# MICROCHIP PIC12(L)F1822/PIC16(L)F1823

## PIC12(L)F1822/PIC16(L)F1823 Family Silicon Errata and Data Sheet Clarification

The PIC12(L)F1822/PIC16(L)F1823 family devices that you have received conform functionally to the current Device Data Sheet (DS41413C), except for the anomalies described in this document.

**FIGURE 1: INSTRUCTION CYCLE DELAY CALCULATION EXAMPLE**

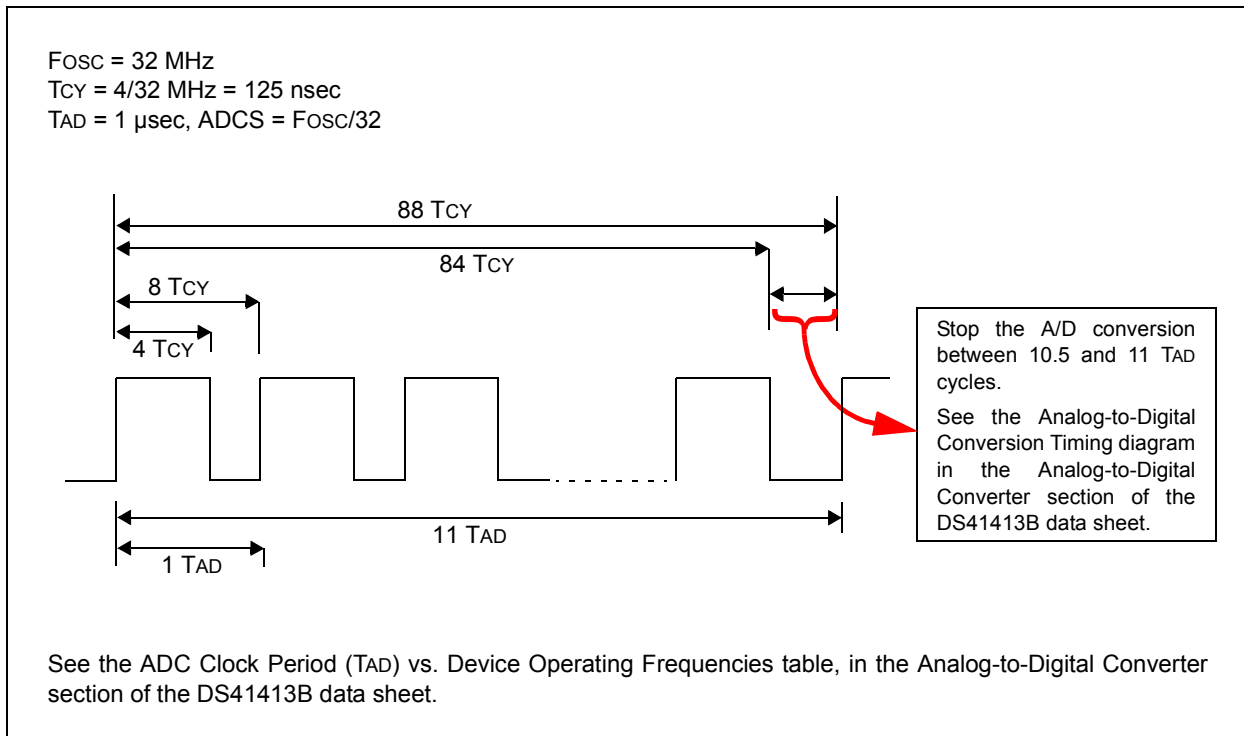
Under certain device operating conditions, the ADC conversion may not complete properly. When this occurs, the ADC Interrupt Flag (ADIF) does not get set, the  $\overline{\text{GO/DONE}}$  bit does not get cleared and the conversion result does not get loaded into the ADRESH and ADRESL result registers.

Method 2: Provide a fixed delay in software to stop the A-to-D conversion manually, after all 10 bits are converted, but before the conversion would complete automatically. The conversion is stopped by clearing the  $\overline{\text{GO/DONE}}$  bit in software. The  $\overline{\text{GO/DONE}}$  bit must be cleared during the last  $\frac{1}{2}$  TAD cycle, before the conversion would have completed automatically. Refer to [Figure 1](#) for details.

In [Figure 1](#), 88 instruction cycles (TCY) will be required to complete the full conversion. Each TAD cycle consists of 8 TCY periods. A fixed delay is provided to stop the A/D conversion after 86 instruction cycles and terminate the conversion at the correct time as shown in the figure above.

**Note:** The exact delay time will depend on the choice of FOSC and the TAD divisor (ADCS) selection. The TCY counts shown in the timing diagram above apply to this example only. Refer to [Table 3](#) for the required delay counts for other configurations.
